VIRGINIA ELECTRIC AND POWER COMPANY
NORTH ANNA POWER STATION UNITS 1 AND 2
SURRY POWER STATION UNITS 1 AND 2
SUPPLEMENTAL RESPONSE TO NRC BULLETIN 2001-01 CIRCUMFERENTIAL
CRACKING OF REACTOR VESSEL HEAD PENETRATION NOZZLES
QUALIFIED VISUAL INSPECTIONS

REQUEST FOR ADDITIONAL INFORMATION
ON THE NORTH ANNA UNITS 1 AND 2 & SURRY UNITS 1 AND 2
SUPPLEMENTAL RESPONSE TO NRC BULLETIN 2001-01
PLANT-SPECIFIC ANALYSIS IN SUPPORT OF A
QUALIFIED VISUAL EXAMINATION
TAC NUMBERS MB2641, MB2642, MB2886 & MB2668

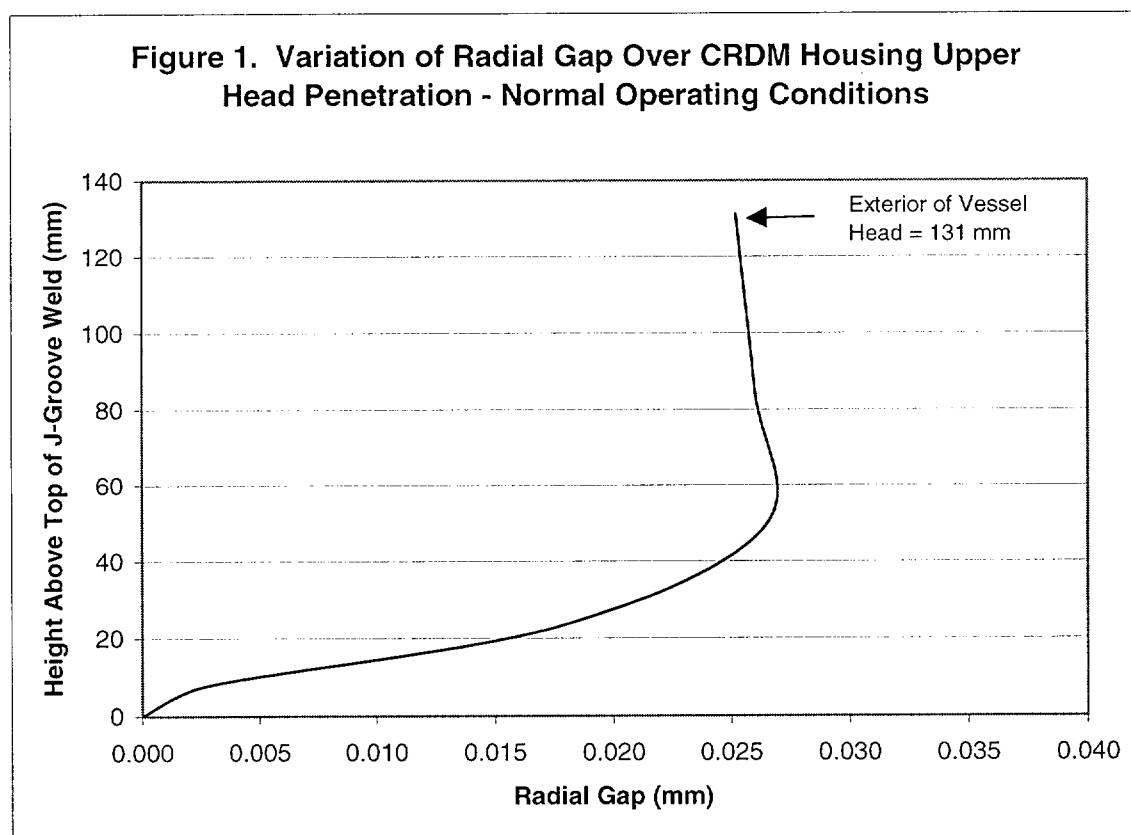
The two-dimensional model used to predict the final interference fit may not be adequate because the CRDM penetration was attached to the vessel head by the J-groove weld at the bottom of the interface only, and effects from this constraint are not modeled in the analysis. Provide results using an approach, which could estimate the variation of the interference fit along the length (axial) of the interface (e.g., using finite element method).

clearance exists for both Surry and North Anna along the length of the head penetration above the J-groove weld (Refer to attached Table T.9.4-7). Since the J-groove weld is modeled in the analysis, the radial clearance at the top of the weld will always equal zero. An additional, handwritten column has been added to Table T.9.4-7 to indicate the approximate distance from the top of the weld to the node pair locations. As shown in this table, the calculated radial gap reaches its maximum value approximately 49 mm above the J-groove weld, and maintains this approximate value to the outside of the vessel head penetration. The condition of the radial gap over the length of the vessel head penetration for normal operating conditions is shown graphically in Figure 1 below.

Based on the results of 1) manual calculations utilizing classical formulations for deflection of cylinders and spheres under internal pressure and temperature, and 2) detailed finite element analyses of the components, it is concluded that a radial gap will exist between the CRDM housing and the vessel upper head penetration. This gap will exist over the full length of the penetration above the J-groove weld. Based on the existence of this gap, leakage from CRDM penetrations (either through J-groove weld or the CRDM housing) can be identified by an external visual inspection of the reactor vessel upper head.
